## **MIDWEST POOLED FUND PROGRAM**

### **Progress Report - Third Quarter 2009 July 1<sup>st</sup> to September 30<sup>th</sup>**

## **Pooled Fund Consulting Summary**

Figure 4. Ohio Anchored New Jersey Shape PCB

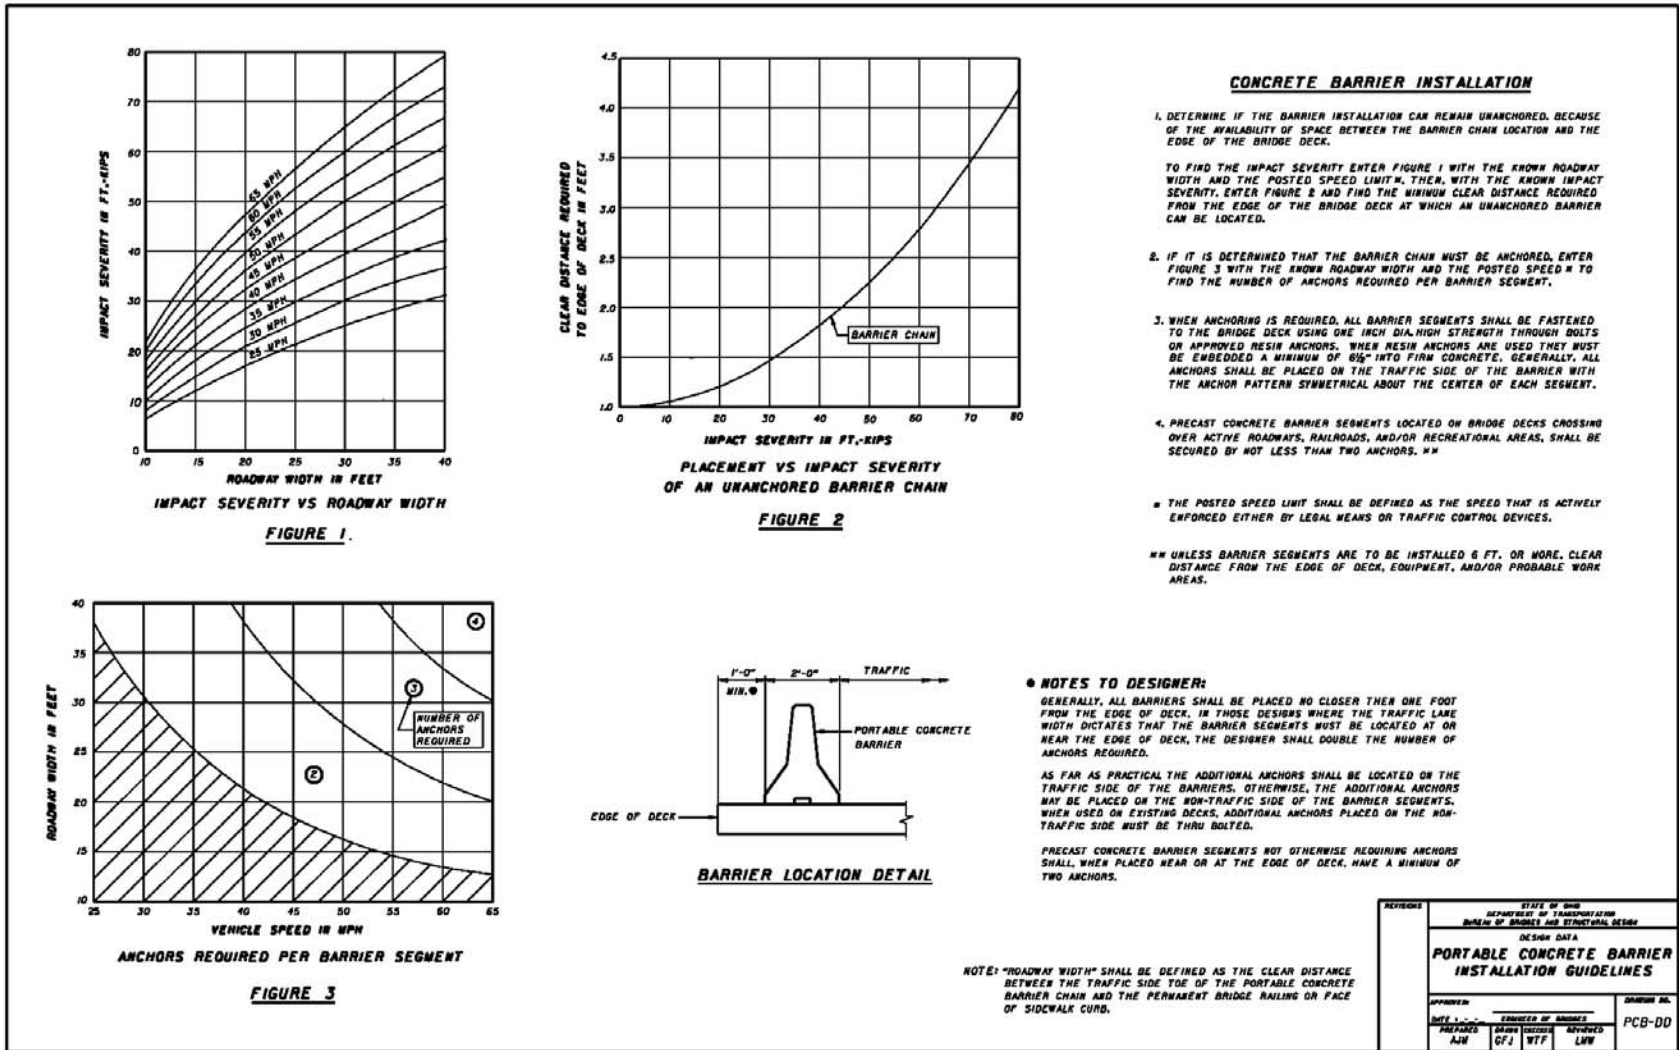
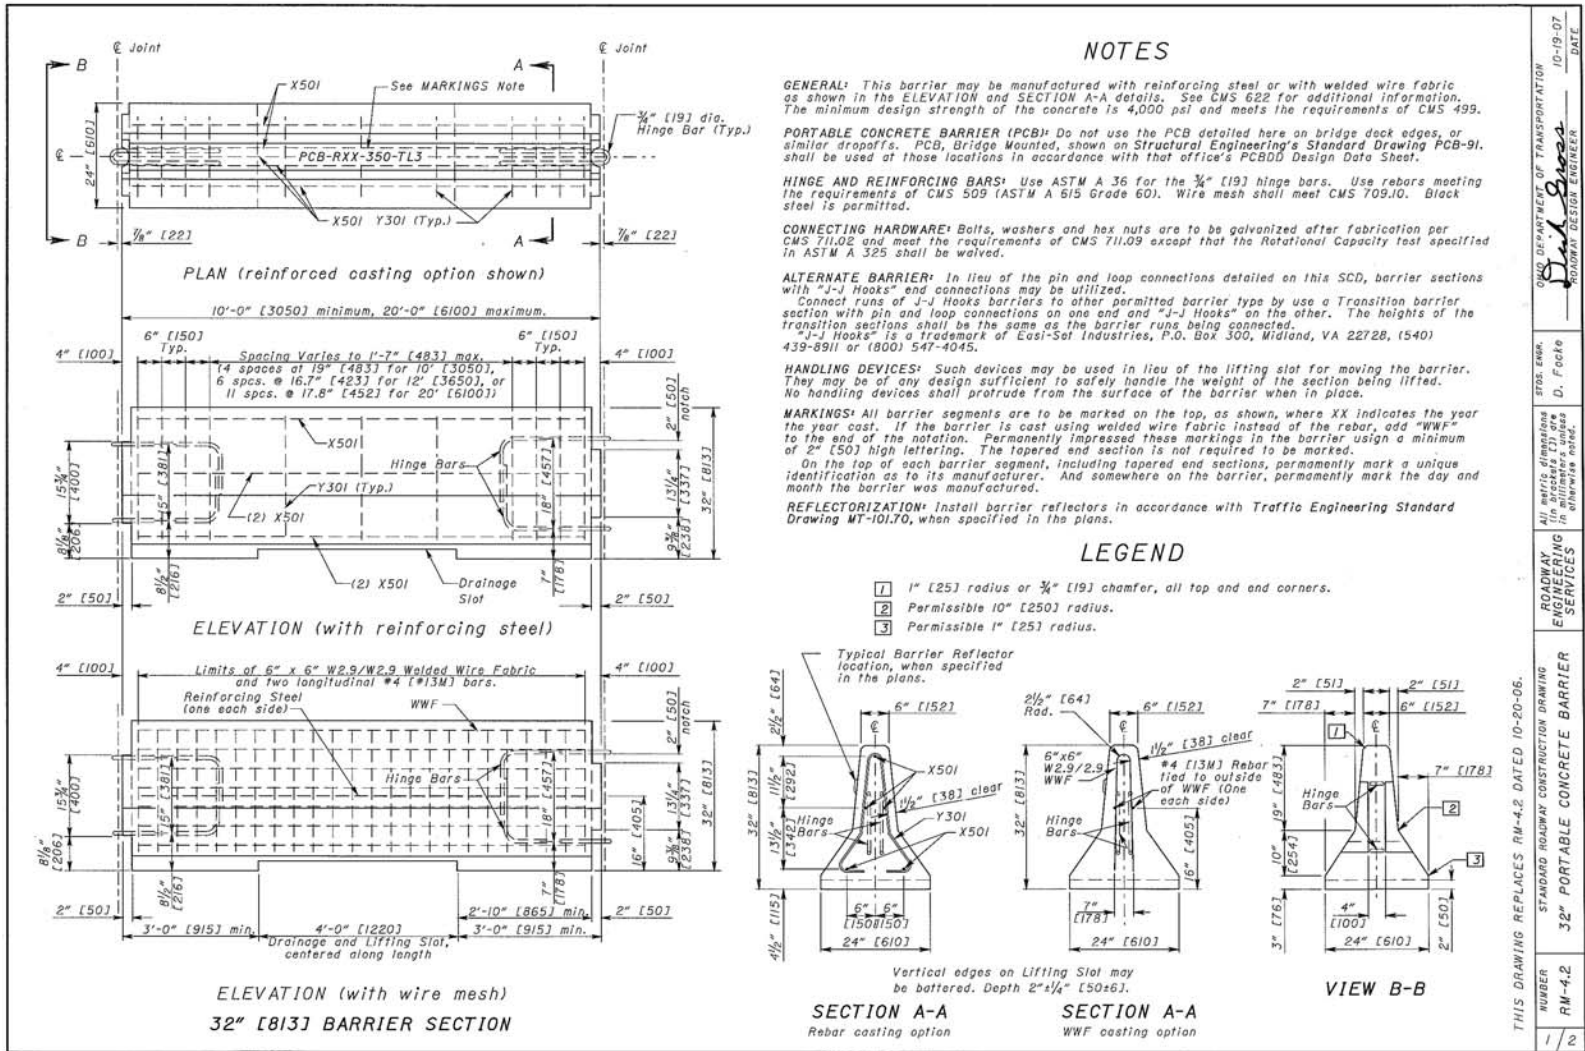
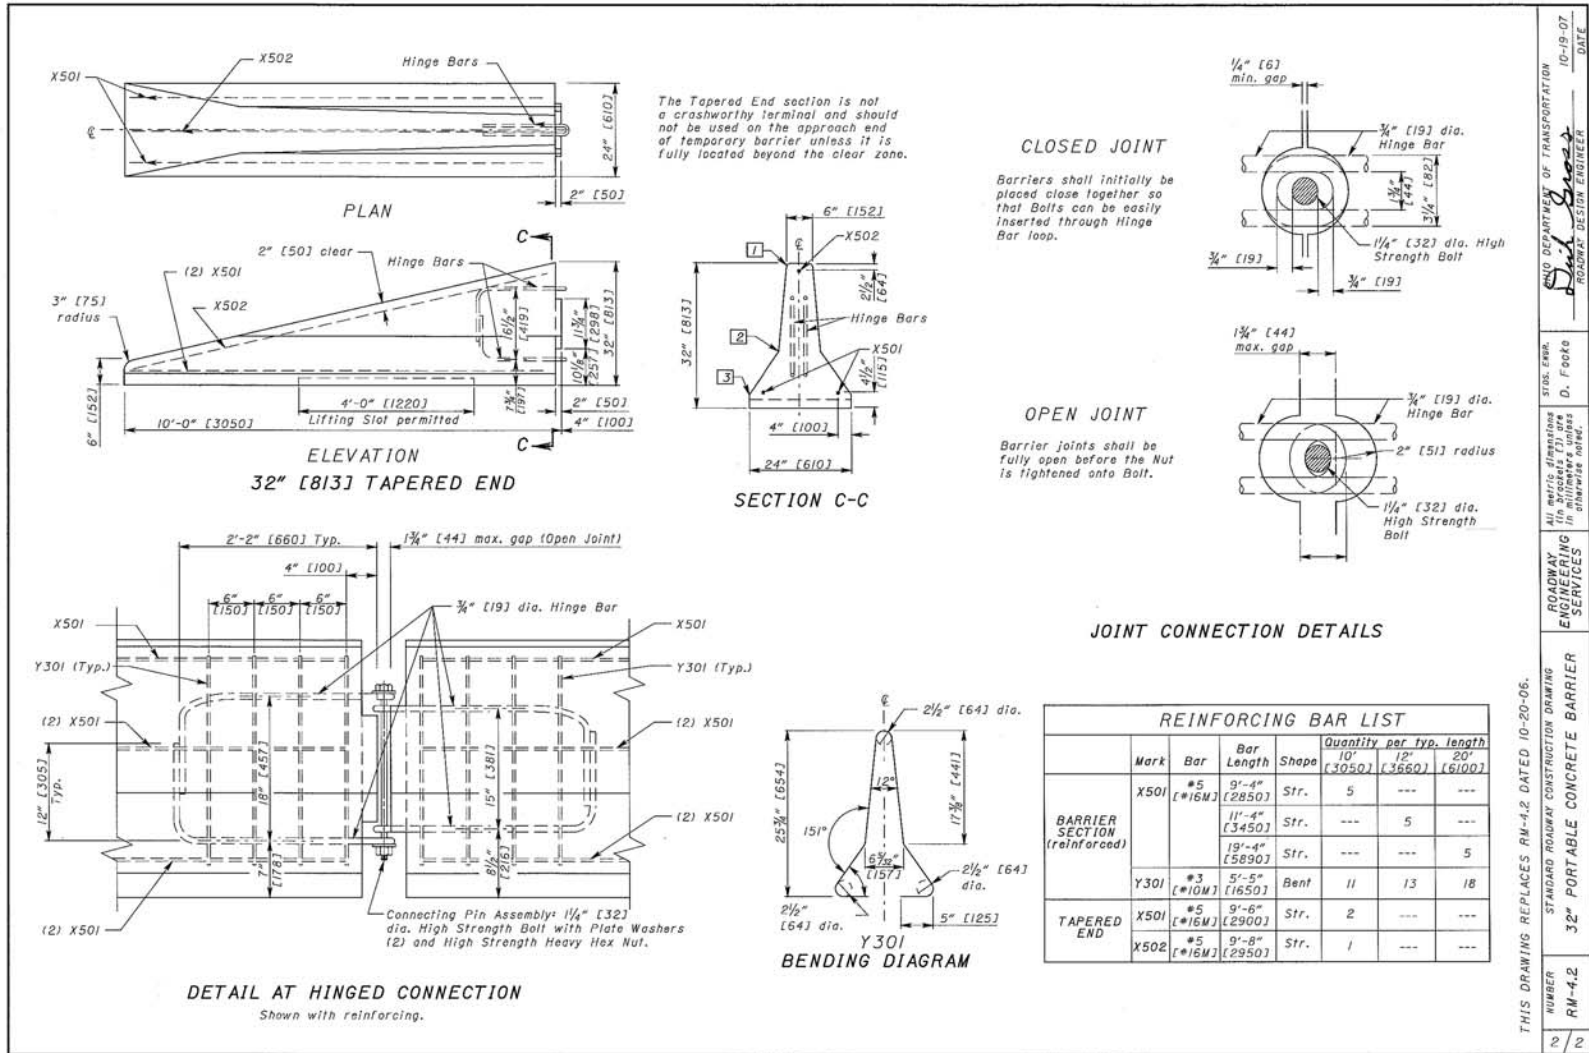
Here are the drawings for New Jersey shaped PCB that is anchored on our structures. These standards are followed on structures or if there is limited deflection.

The run of New Jersey shaped PCB before anchored pieces do not have to be anchored and have a deflection of 5.5'. Here is the drawing for that.

While the transition we designed worked successfully with the Kansas F-shape barrier, we have concerns with regards to how it will function with your PCB design. I will try to lay out these concerns below.

1. First, we do not believe that the anchorage system on your PCB is equivalent to the anchorage used in the transition we developed. Your barrier uses 1" dia. high-strength steel rods embedded 6.5" into the concrete with a grout mixture. Our experience with this type of anchorage is that it is not sufficient to develop much of the strength of a 1" dia. high-strength steel rod. We believe that these anchors will pull out of the concrete surface much more easily than the anchors we tested with. This will change the stiffness and deflection of the anchored barriers as compared to the ones use in the transition we tested.

2. We did recognize that you have more anchors than use used in our anchored barriers, but that is another cause for concern. We do not recommend placing anchors on the backside of barriers. There are concerns that placing anchorage on back side of the barrier can induce increased vertical rotation of the barrier segments which could increase the potential for vehicles to climb the sloped barrier face and become unstable. Thus, we would recommend no anchorage on the backside of your barrier.

3. Barrier reinforcement in your barrier is not sufficient to derive the full strength of the 1” dia. high-strength steel rod used. In our anchored barriers, the anchor pockets have reinforcement loops that go around the packet to contain the anchors. Without this type of reinforcement, we do believe your anchors will fracture through the anchor pocket and become ineffective.

4. I also noted that you allow the use of JJ-Hooks barrier segment connections with your PCB. We would not recommend this connection for use in an anchored barrier system. The JJ-Hooks connection is fine for free-standing systems. However, to be safely used in an anchored barrier or approach transition, the barrier joints must have comparable or greater torsional rigidity about the longitudinal barrier axis when compared to that of the as-tested configuration. JJ Hooks connection is not similar in torsion to the Kansas barrier joint, and the JJ Hooks connection is also non-symmetric in that it has different capacities depending on the direction it is loaded.

At this time, if you need to have anchored barrier sections and an approach transition from free-standing barrier, we would suggest using the Kansas F-shape design and the transition and tie-down systems we have tested with it.

In order to adapt your barrier to safely use the approach transition, we would recommend that you change your current barrier and anchorage system to:

1. Remove backside anchors.
2. Increase anchorage of front anchors to develop the full strength of the threaded rods.
3. Reinforce the anchor pockets.
4. Disallow the use of JJ-hooks in the anchored configuration

Figure 9. Vertical Bumper Displacement for 6" Type B Curb and 3" G-3 Gutter

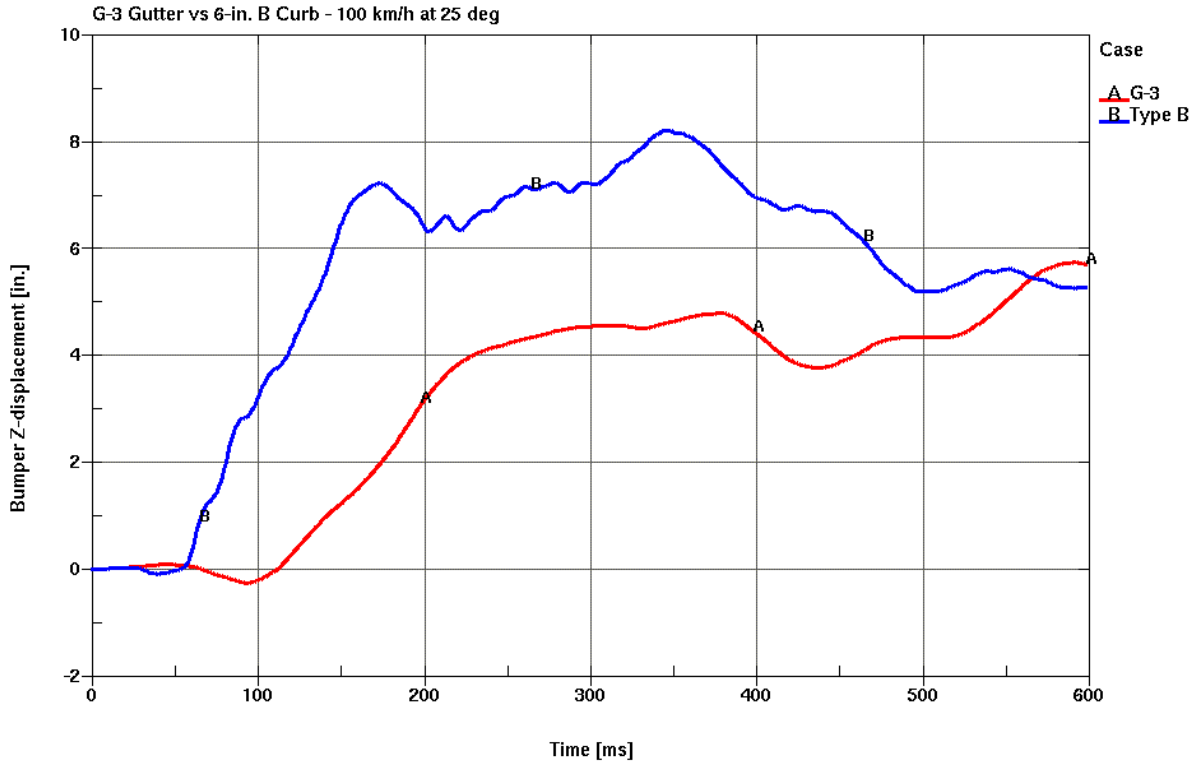
I have another question about the MGS. see attached for the IL Tollway standards for gutter used adjacent to MGS. On our mainline high-speed sections, G-3 gutter is used where necessary to handle the pavement drainage and/or to prevent sideslope erosion. we currently offset the guardrail post 6" behind the back of gutter, which means that the distance from the flowline to the face of rail is 11.75". What are your thoughts on this configuration versus the 6" high curb with a 6" offset that was tested?

In the IL Tollway detail, the MGS rail face is positioned 11.25 in. behind the toe of the G-3 gutter. In addition, the top of the rail is positioned 32.5 in. above the roadway relative to the bottom of the curb or swale. The curb height is 5.25 in. tall, as measured between the curb toe and the back of the curb.

Although there are slight differences between the successfully crash-tested system and the IL Tollway detail, we believe that the noted system with MGS in combination with the G-3 curb would provide a crashworthy system. However, we do not have physical or scientific evidence to support this opinion and would like to conduct a brief analysis to investigate the alternative scenario. As such, we used LS-DYNA to evaluate and compare the two scenarios since we have experimental data to validate the 6" Type B curb cases.

Dr. John Reid has made a very brief comparison between the two noted curb geometries – the 6-in. tall AASHTO Type B curb and the Illinois Tollway's wedge-shaped curb. This initial investigation included both an examination of vehicle trajectories and motions with and without the guardrail in place behind the curb. From this study, the use of the wedge-shaped curb in combination with the MGS (located per your prior CAD details) does not appear to degrade barrier performance over that observed for the MGS with the 6" Type B curb. As such, MwRSF is not concerned with placing the MGS behind the wedge-shaped curb using the previously noted details.

Figure 10. TL-2 Barrier

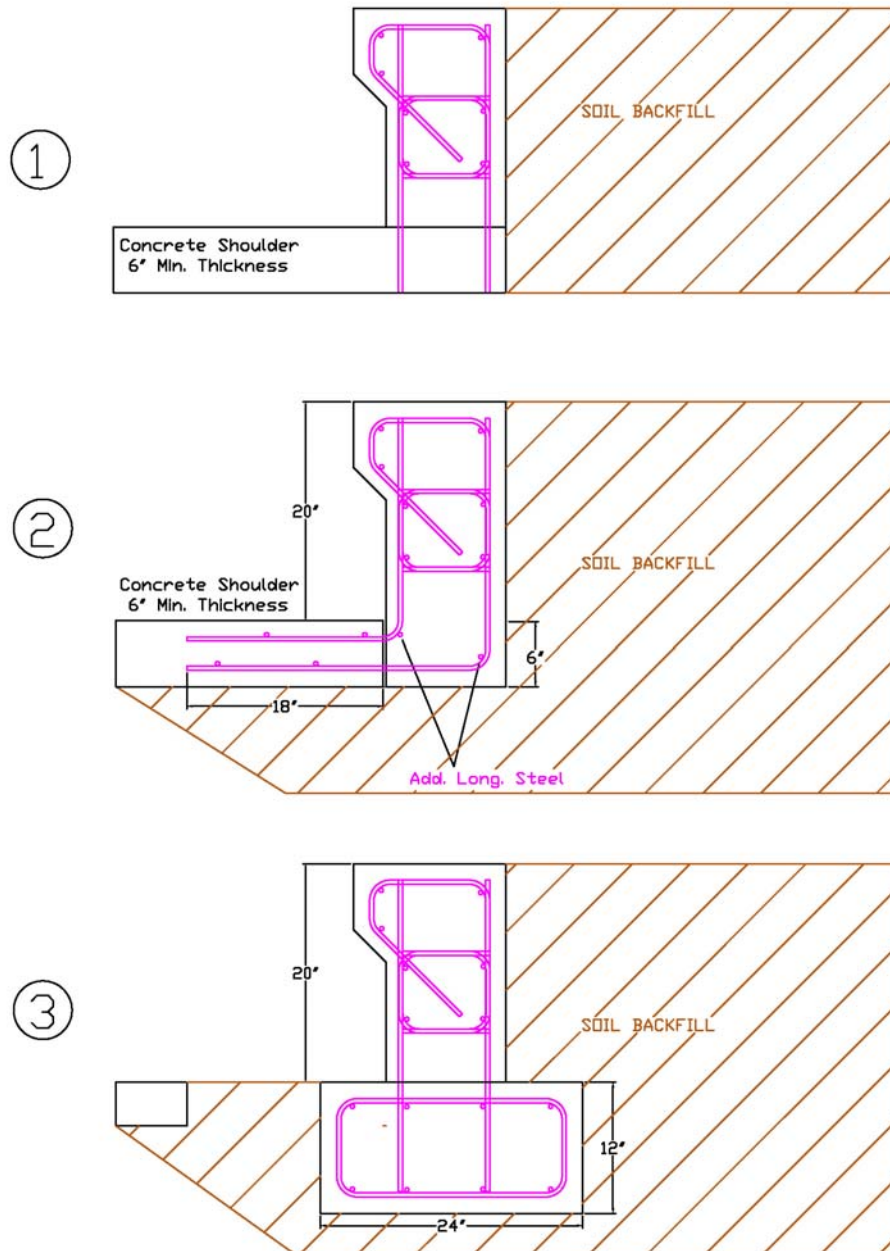
Wisconsin was interested in installing a TL-2, low profile bridge rail that will be backfilled with soil and were looking for guidance pertaining to the foundation/anchorage requirements. The barrier in question was the TL-2 concrete barrier designed by MwRSF in report TRP-03-109. It was planned for use in both median or roadside applications. The backfill was expected to be 21 feet in median applications, and the roadside application may place a 6:1 on the backside. The roadway in question was being reconstructed. In the median, the expected barrier placement was at least 2' from edge of lane, and on the roadside the region is pushing for 10' shoulder on the outside, but may not get it.

To adapt the low profile, TL-2, concrete bridge rail to roadside applications, I see three options. These options are shown in the PDF file in the folder noted below. Also, 2 digital videos of the full-scale crash test are in the folder.

- (1) Place the barrier on top of the shoulder and tie the vertical steel directly into the shoulder slab. This, to me, seems like the easiest and most efficient method. Even if the shoulder slab is only 6" thick (shorter than the development length of the rebar, and shorter than the 8" embedment depth used during the crash test), the combination of overturning resistance provided by the rebar and the resistance provided by the soil backfill should create adequate strength to redirect a vehicle. Also, the rebar ties should prevent the barrier from lateral and rotational movement due to lateral soil pressure. Again, I would recommend this method.

- (2) Place the barrier adjacent to the shoulder slab, extend the barrier downward, and tie in the internal steel to the slab through the end. This should also provide adequate strength to resist impacts and lateral movement due to soil pressure. However, the internal steel reinforcement must be designed correctly to carry the load and it will be more difficult to cast with the bends.

- (3) The barrier is not in contact with the shoulder in any way. For this method, the barrier must be attached to a footer, as shown. The footer would need to be at least 12" in depth and run the length of the barrier. Calculations for the necessary internal steel can be done using the design method described in the MwRSF report – "Development of a Stand-Alone Concrete Pier Protection System" Report No. TRP-03-190-09. This will prove to be the most costly design.

Figure 11. Kearney Bypass

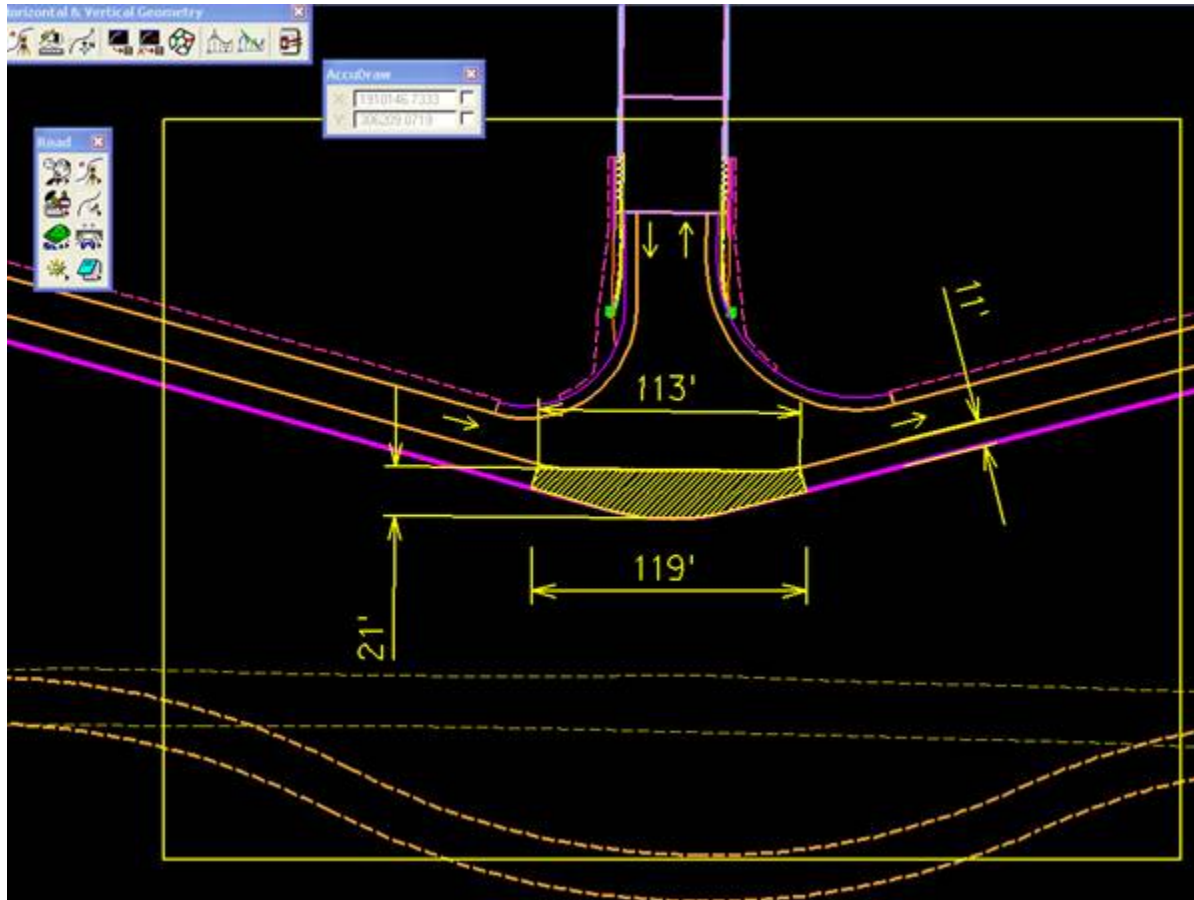
The attached drawing (at a scale of 1:40) is a simplified sketch of the south section of the interchange. In order to allow for WB-62 truck turning movements, the current design provides about 21' for a crash cushion/impact attenuator in front of the jersey barrier. Please let us know if there is a device that will protect or lessen head-on impacts within this limited space.

I've attached my recommended configuration for the sand barrel crash cushion. It takes a lot of barrels to protect such a wide area!

- (1) Barrels are 3 ft in diameter and should be spaced 6 in. apart.
- (2) The gray line in the drawing represents the 24 in. clear space recommended between sand barrels and the hazard.

- (3) The black line has the same dimensions as the yellow hatched area on your drawings.
- (4) The head-on impact scenario requires 6 rows of barrels to safely stop errant vehicles – thus the 21 ft length shown in your drawing (yellow hatching) needs to be extended 1.5 ft to 22.5 ft.
- (5) Most rows contain only 1 type (weight) of barrel, but there are 2 exceptions. Rows 2 and 3 have lighter barrels on the ends. This is designed for end in impacts (not necessary for on ramp, but included to make system symmetric).

- Row 1: 31 – 200 lb. barrels
- Row 2: 31 – 400 lb. barrels and 2 – 200 lb. barrels (1 on each end)
- Row 3: 29 – 700 lb. barrels and 2 – 400 lb. barrels (1 on each end)
- Row 4: 23 – 1400 lb. barrels
- Row 5: 15 – 2100 lb. barrels
- Row 6: 7 – 2100 lb. barrels
